MPC7450, MPC7451, MPC7441 Chip Errata

This document details all known silicon errata for the MPC7451, MPC7450, and MPC7441. The MPC7450 has the same functionality as the MPC7451 and MPC7441, and any differences between the other microprocessors are noted in the document. The MPC7451, MPC7450, and MPC7441 are PowerPC™ microprocessors. [Table 1](#) provides a revision history for this chip errata document.

Figure 1. Example 1 with Condition 2

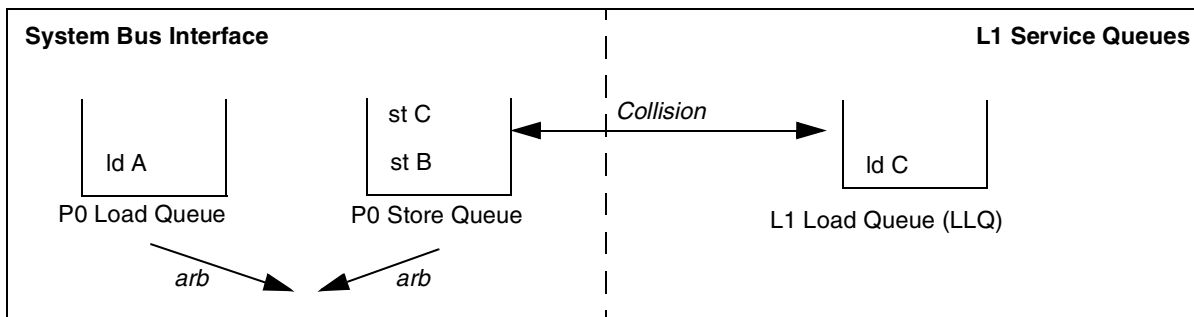
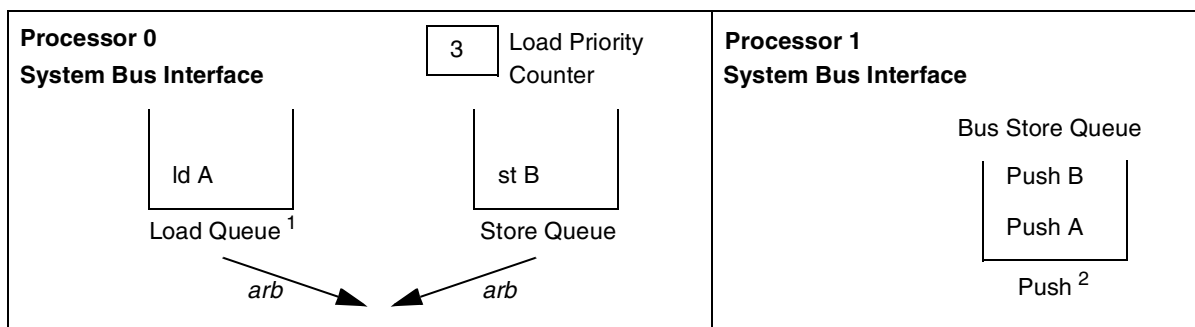
Example 1: The processor may make a load request to address 'A,' which gets retried. As a result of one of the conditions stated above, the high priority mechanism within the processor engages, and the processor goes to the external bus with a store queue request to address 'B.' The system must be able to process the store queue request to 'B' (and potentially several other store queue operations as described for condition 2), because the store queue may not relinquish control until 'B' (and others) successfully completes its (their) address tenure(s). This is shown [Figure 1](#), where condition 2 has caused the high priority mechanism to be engaged.
